H. B. ROBINSON STEAM ELECTRIC PLANT, UNIT NO. 2  
DOCKET NO. 50-261  
LICENSE NO. DPR-23  
REVISION 1 - FINAL STEAM GENERATOR REPAIR REPORT  
REVISED FIGURES

ATTACHMENT 1  
REVISED FIGURE LIST

Revision No. 1 Instruction Sheet - Figure Changes

FIGURE 3.0-2

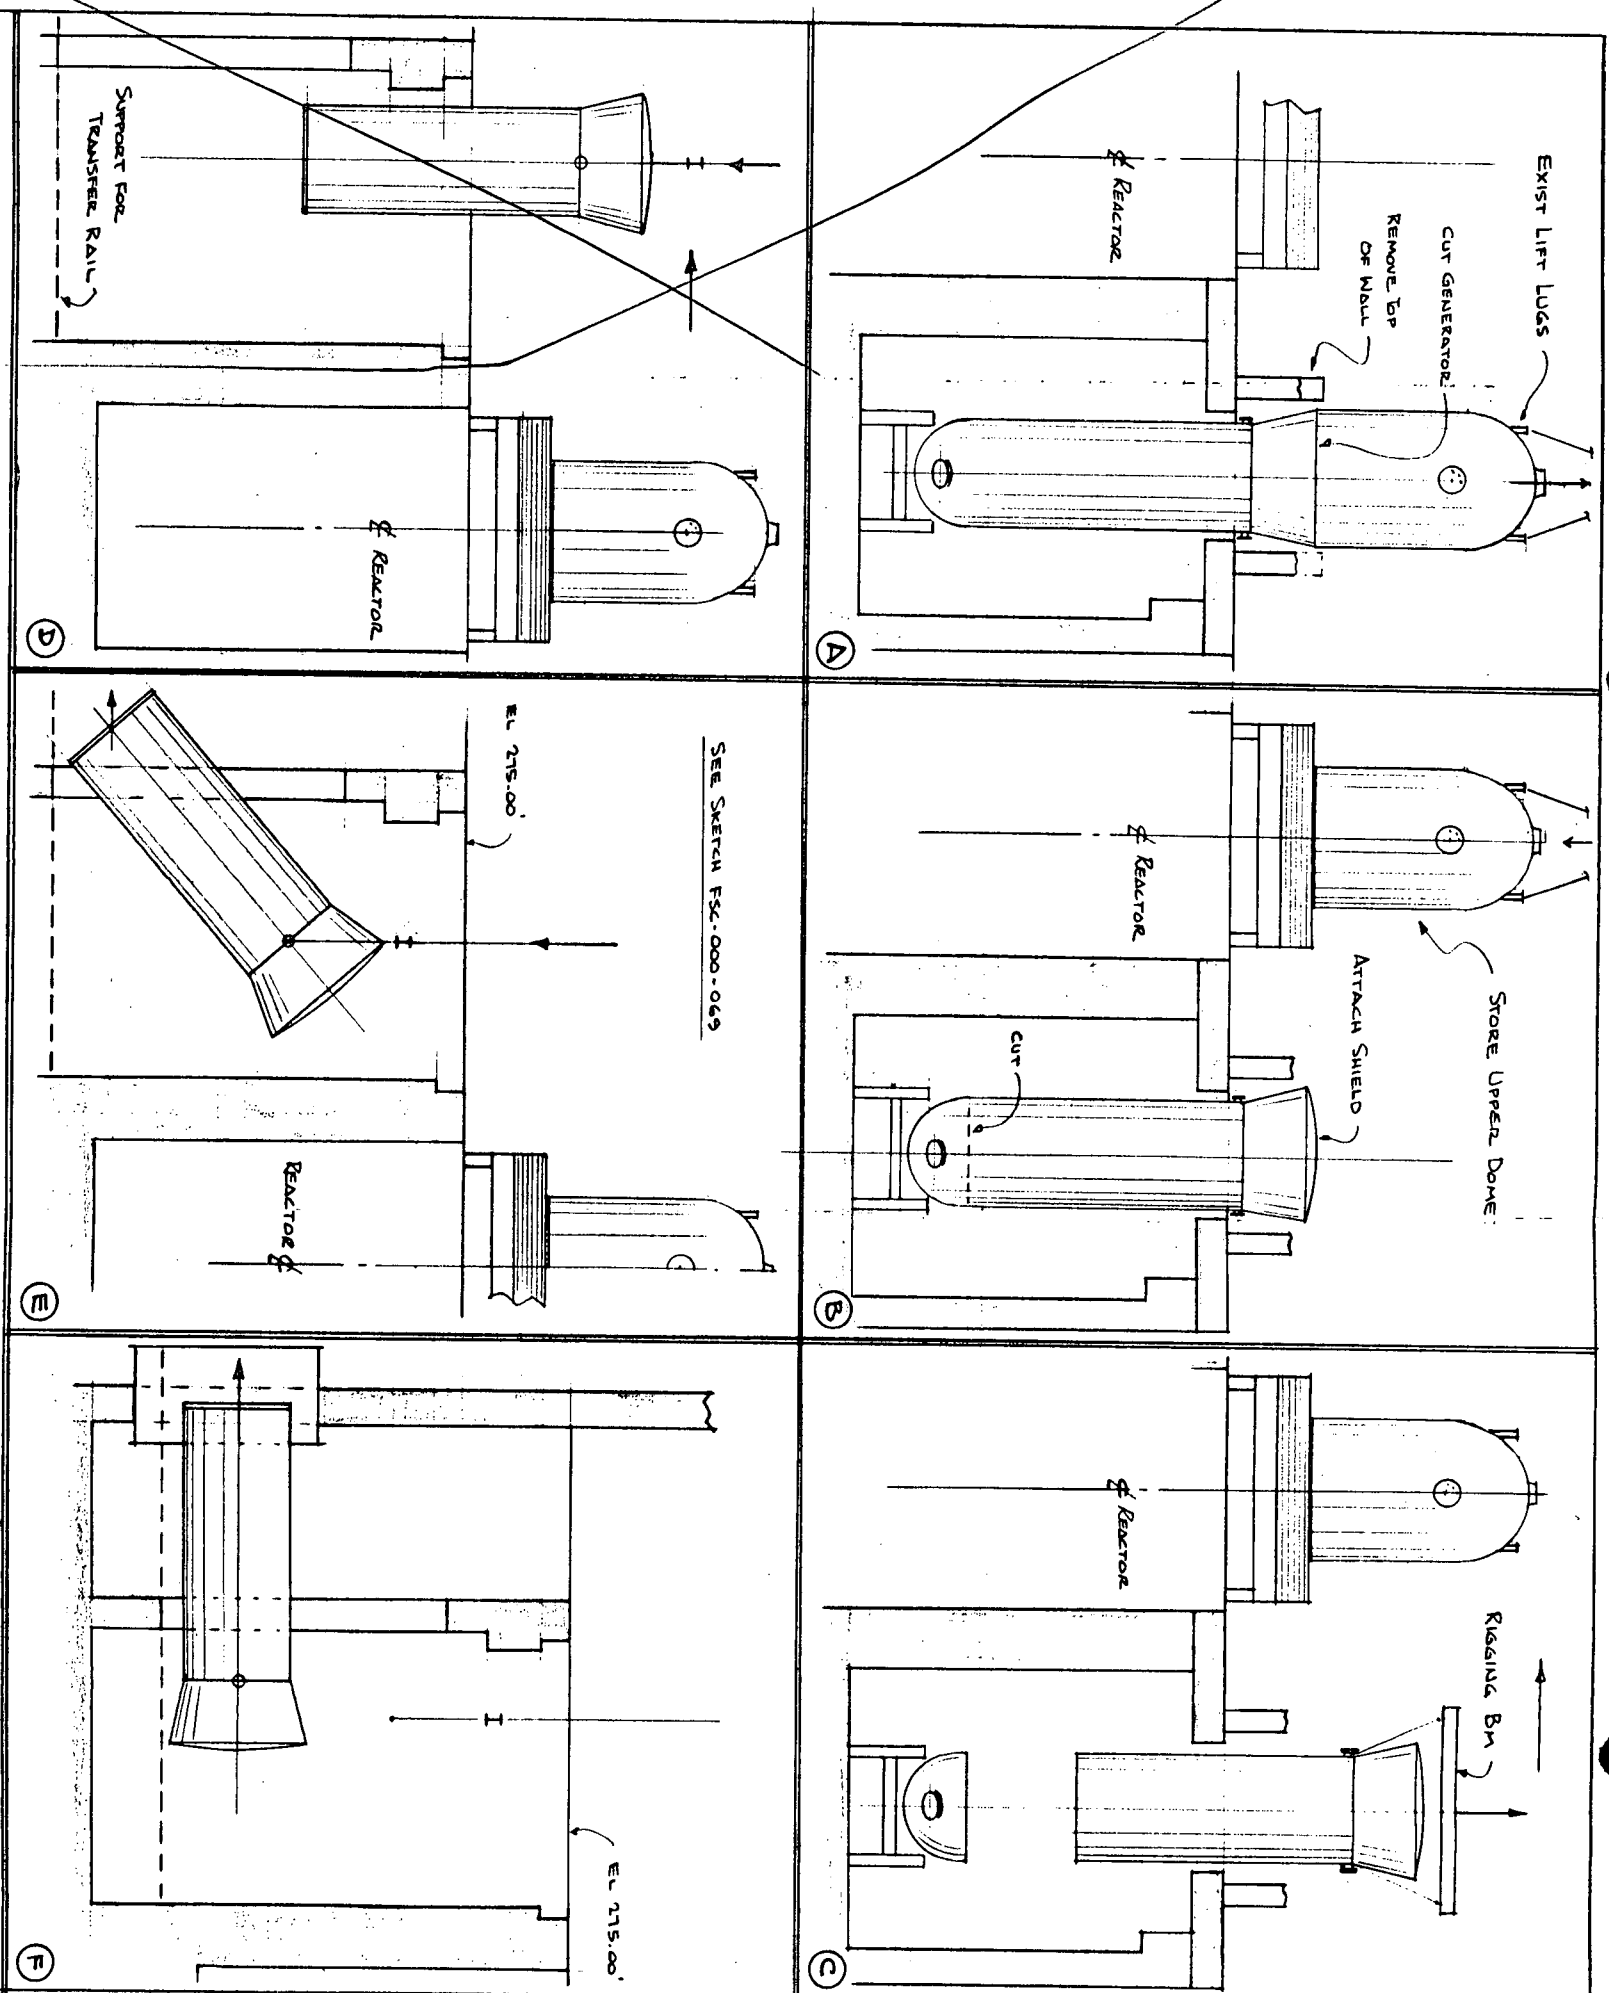
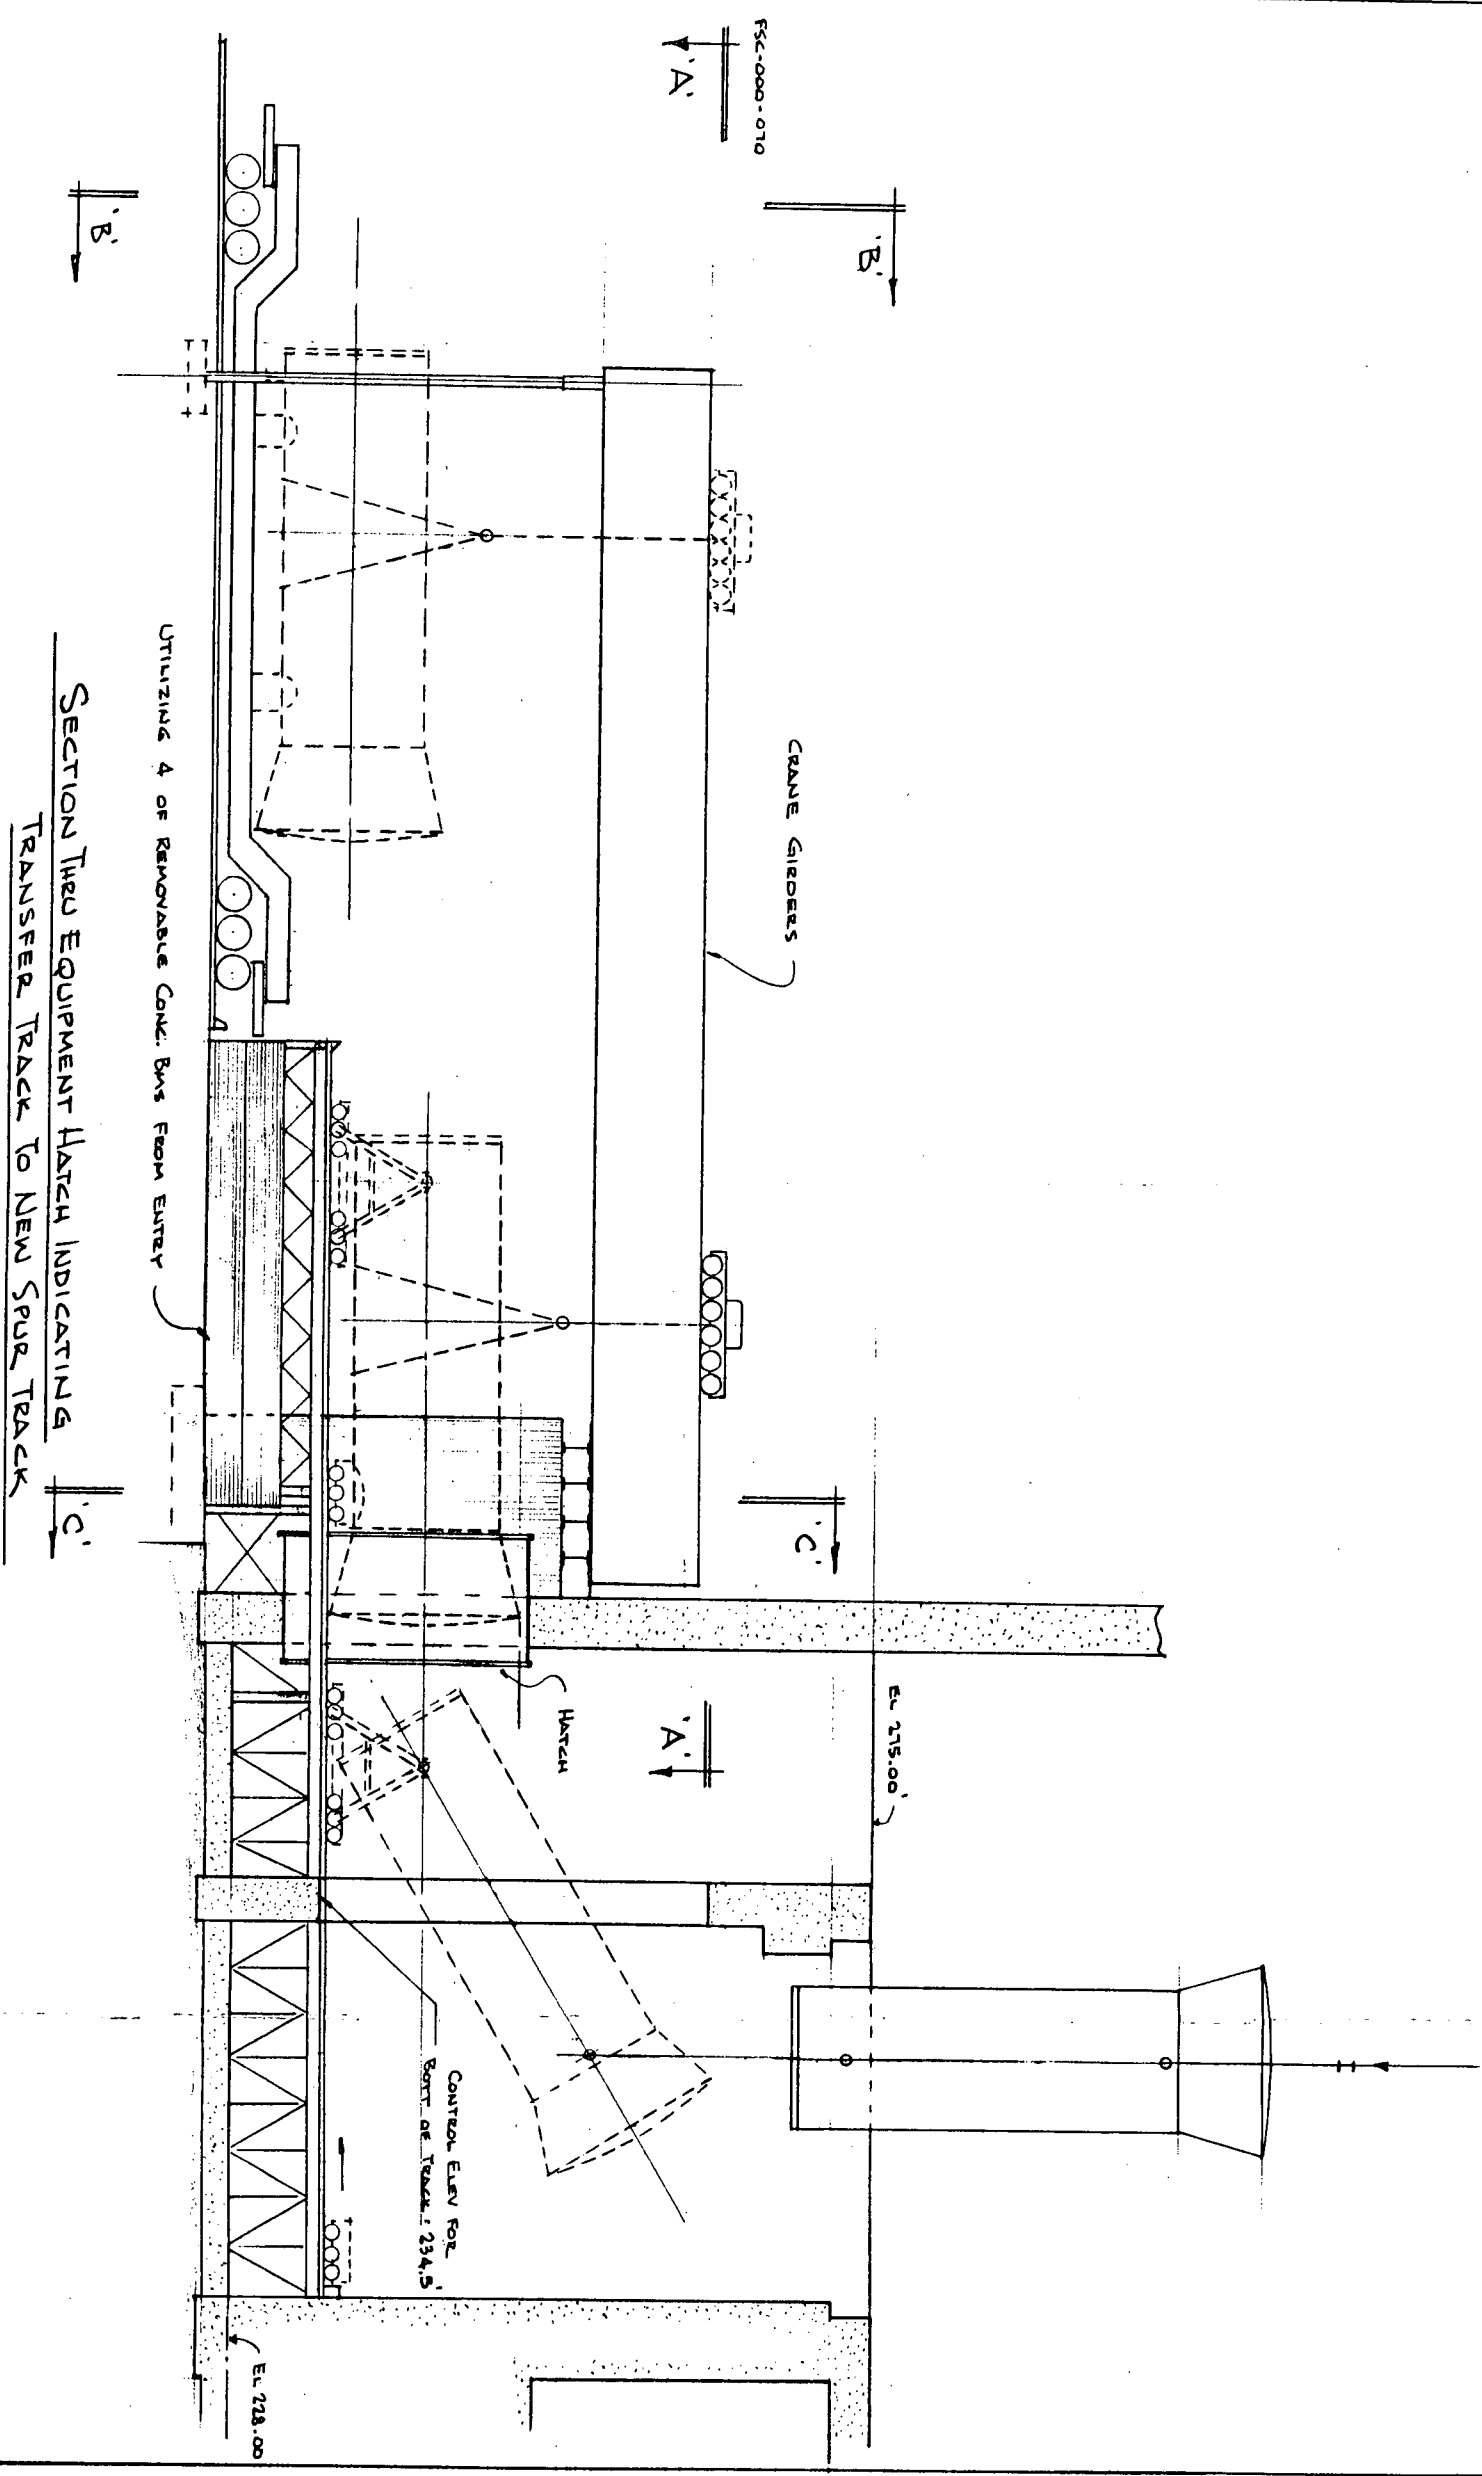
<u>Figure No.</u>	<u>Major Changes</u>
3.0-2	Removes upper dome from frames B through E. Adds upending/downending assembly and low profile saddles.
3.0-4, Sheet 1	Removes lifting frame assembly, revises design of transfer skid, and adds upending/downending assembly.
3.0-5, Sheet 2	Removes lifting frame assembly and adds a crane.
3.0-6	New drawing - Removal sequence for upper domes.
3.1-1	Revises location of new SG storage area and tomb. Revises site plan for new structures.
3.1-2	Removes dress out area due to new crane location, adds upper assembly storage stands.
